INDESIT company

BA35FNFGR

F033773

RE0231T0 (... - 61112...) Exploded views

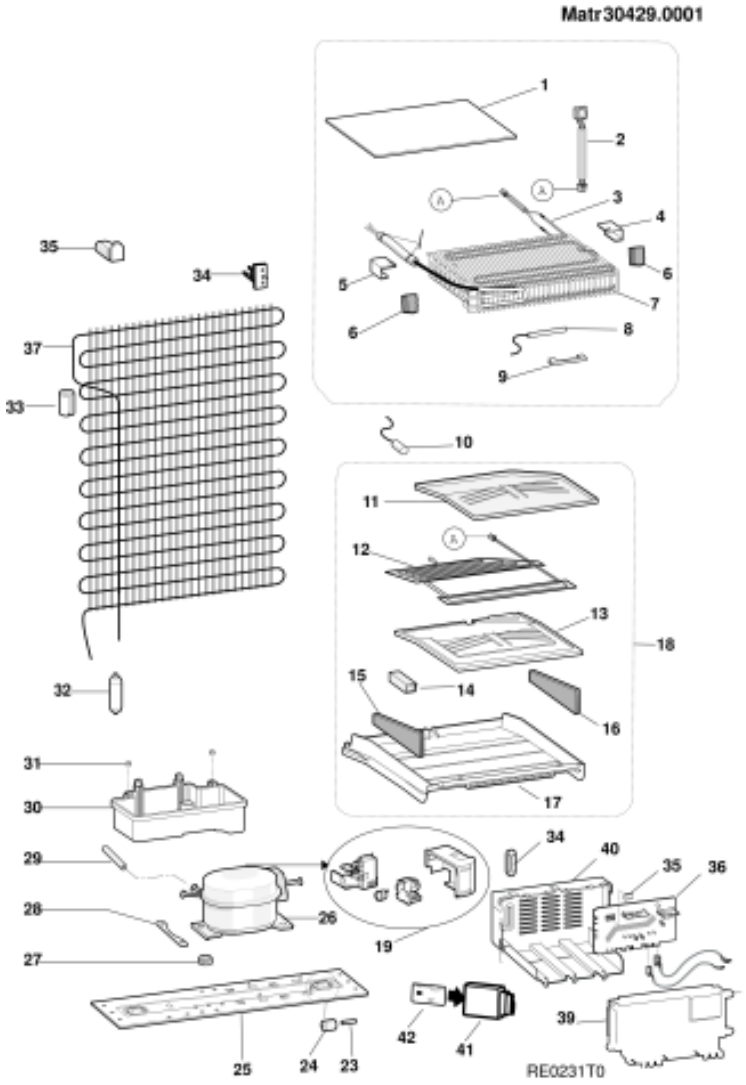
0999376: ICE FORMATION AT THE BACK OF THE EVAPORATOR

Below modifications have been performed to prevent ice formation at the back of the evaporator on L70 combies. These new parts can be supplied as an assembly C00141277
1- Spugnetta evaporatore left and right have been modified since 12/08/2005. Spare part codes remain the same (C00094468-C00094467). These parts must be replaced together in case of necessity of the replacement.

2- Power of the rezistance for divisorio camere has been increased from 40W to 50W since 03/10/2005. Spare part code remains the same (C00095774).

3- Power of the rezistance for evaporator has been increased from 140W to 150W since 26/09/2005. Spare part code remains the same (C00115199).

4- Drain hose end piece C00141278 has been used for draining the water to the evaporating tray since 26/09/2005.

5- Fan motor plastic assembly has been modified. The hole for propeller has been modified to prevent friction between propeller and fan motor plastic since 03/10/05.
Spare part code remains the same (C00116498).

These new parts can be supplied as an assembly C00141277.(TB001014 - ex.TECHNICAL NEWS STN-CL 0511.1)

0999364: new fin evaporator and rezistance

Since 01/04/05 new fin evaporator end new rezistance will be used on EU combi models. New parts as an assembly can be used on the appliances which are produced before the modification.

New parts;
115198- fin evaporator
115199- new evaporator rezistance

To fit new evaporator follow below procedure;
· First of all fin evaporator should be positioned at right and back of the freezer roof and than right bracket should be screwed like previous manner (the same track of the hole for right bracket exists on the cabinet). Use the evaporator as a template to screw and position the left bracket symmetricaly.

RE0250T0 (... - 61112...) Exploded views

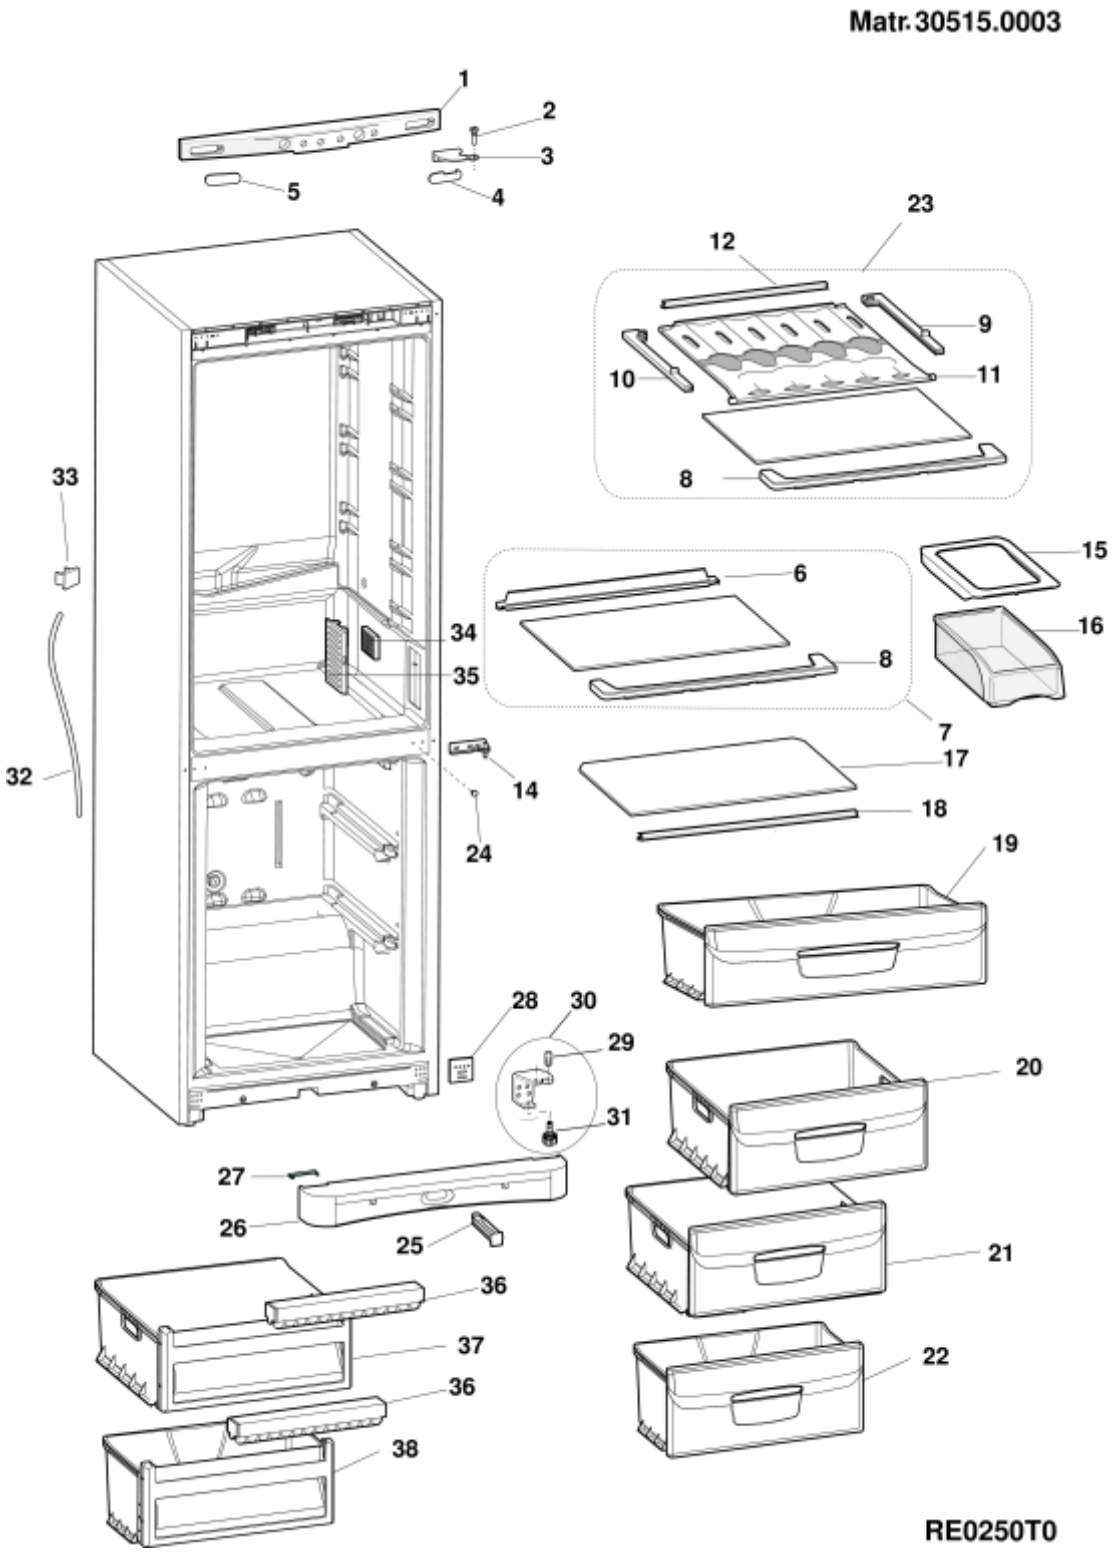
n3010b02: PLAYZONE ELIMINATION

Playzone shelf has been eliminated in Manisa and Lodz production and replaced with a normal shelf already present in interested models.
These spare parts will not managed at the end of stock.

This modification changes also model name of the product without modification of industrial code, in following way:

RE0252T0 (... - 61112...) Exploded views

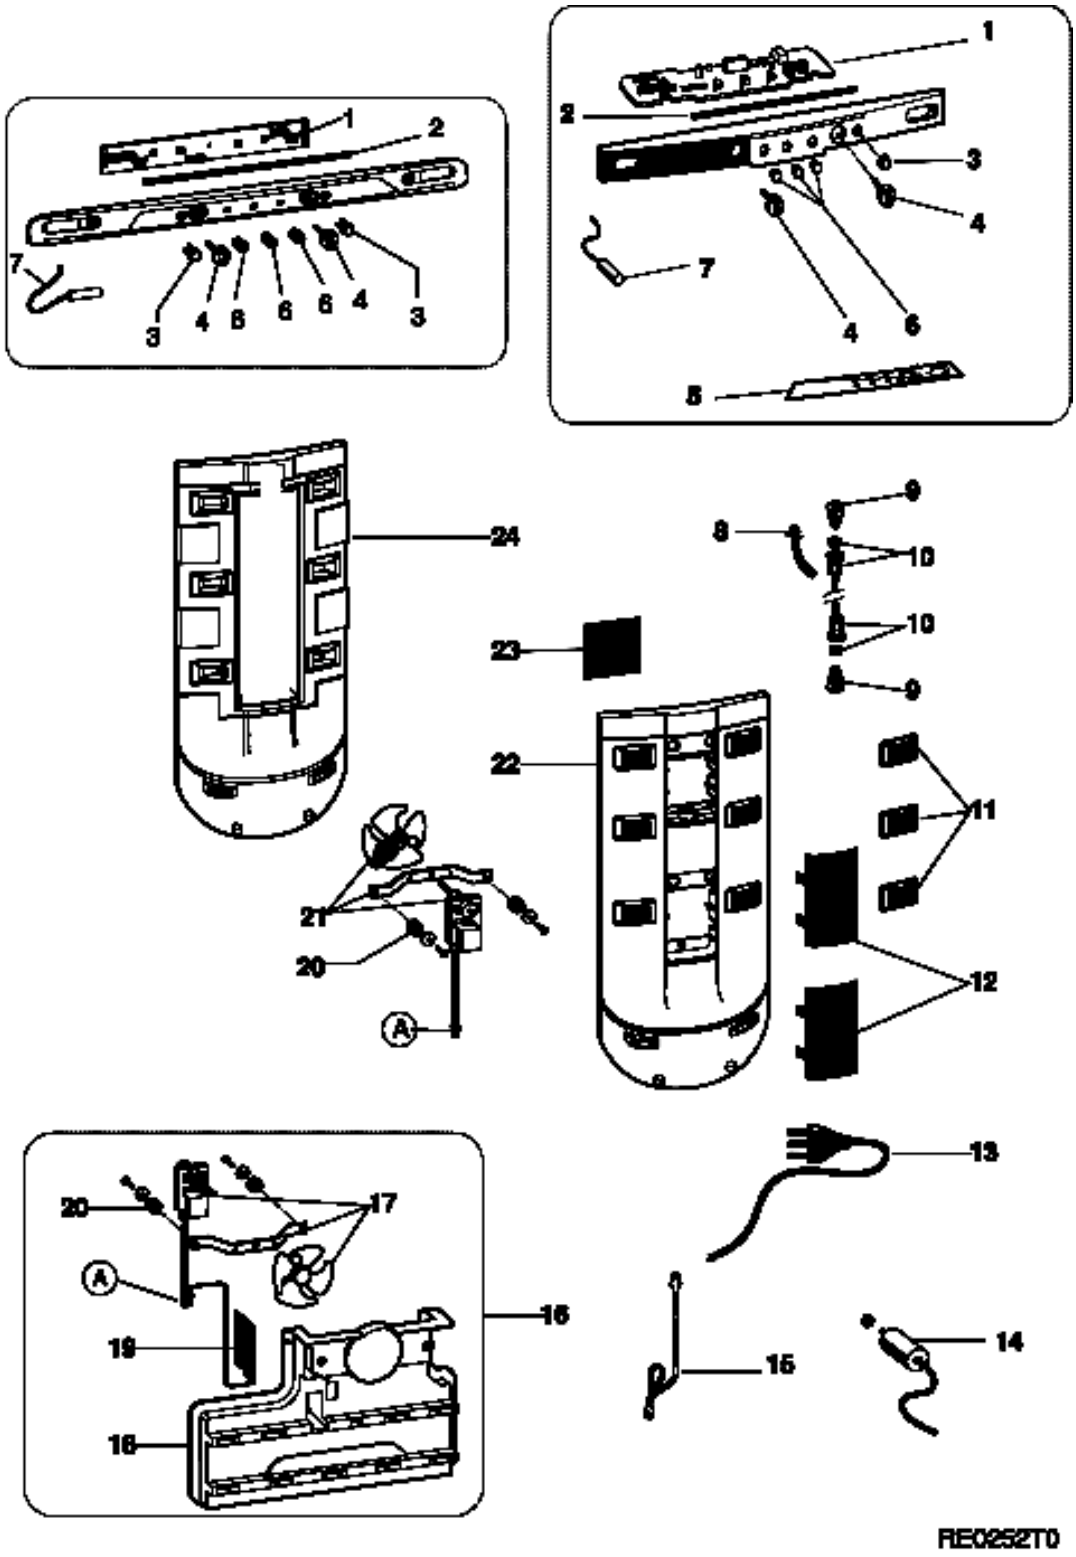
0999379: TWO HOLES HAVE BEEN CANCELLED ON MULTIFLOW FOR COMBIES

Due to low temperature at the lower part of the fridge section on Manisa combies two holes which are placed on multiflow cover have been cancelled for all combies since 13/04/2006.
